Revised Independent Assessment of Re-revised Basement Excavation Justification for Planning Application 2014/7908/P

140-146 Camden Street

Client London Borough of Camden

Date July 2015

Figure 1: Extract from the Environment Agency's map of 'Risk of Flooding from Surface Water'. Ordnance Survey © Crown copyright 2014. All rights reserved. Licence No.100051531.

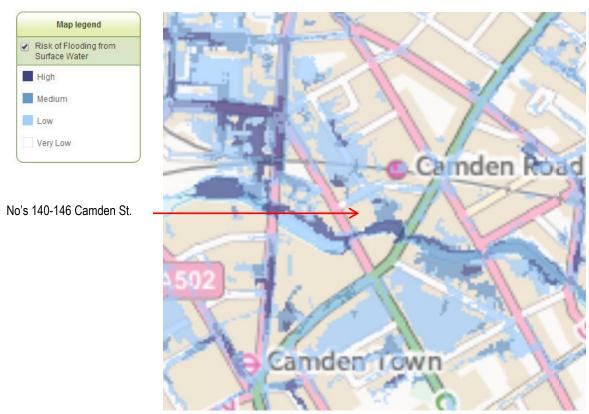
2.3.21 An extract from the EA's map of 'Risk of Flooding from Surface Water' (EA website, 2014) is presented in Figure 1 below, which shows that a 'High' risk of surface water flooding from the adjacent canal is predicted, including the towpath alongside the site of current interest. Appropriate flood resistance measures have now been recommended in the Flood Risk Assessment.

2.3.22 It is understood that the published Environment Agency map of surface water flood risk is less detailed than the full model, so the EA could be consulted for further details of the maximum predicted flood level of water from the canal.
